# Access Compliance Report

## Public Rights-of-Way

### (Pedestrian Signals)

| ADA ID: 26ED4E01C597                    | Signal Type: Two Push Buttons-APS | Overall Compliance: No                  | Severity Score: BTN 1:N/A BTN 2: N/A No BTN: N/A |

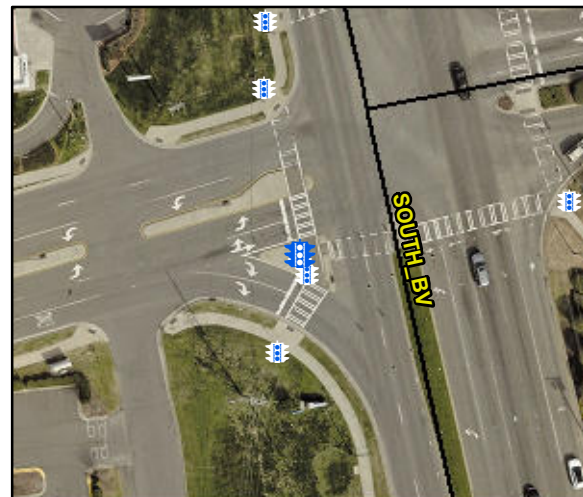
Possible Solutions: Replace Signal Push Button With APS Button on New Post.  
Remove & Relocate Sign. Remove & Replace Replace APS Button With New APS Button.  
Remove and Replace Clear Space.

PROW/ADA: , TMUTCD 4e.08, R404.2, R404.7.3, R406.2
